Product Announcement

Improved Limit System for Electronic Operators

Manaras-Opera's Improved Limit System

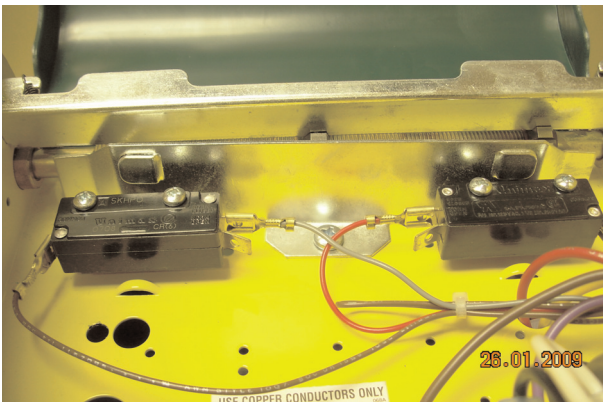
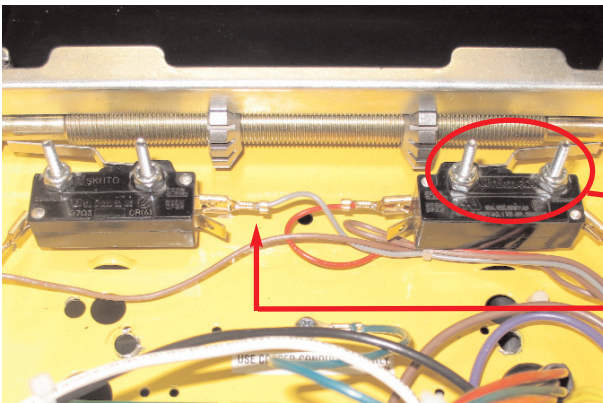
Limit System as it used to be ▶▶▶

New Improved Limit System ▶▶▶

Screws have been replaced
with easy-access studs

Unique central lever has
been eliminated

What has changed

- Unique central lever has been eliminated.
- Each limit now has an independent lever which is specifically formed for a more consistent activation.
- The limit fastening screws have been replaced with easily accessible studs.
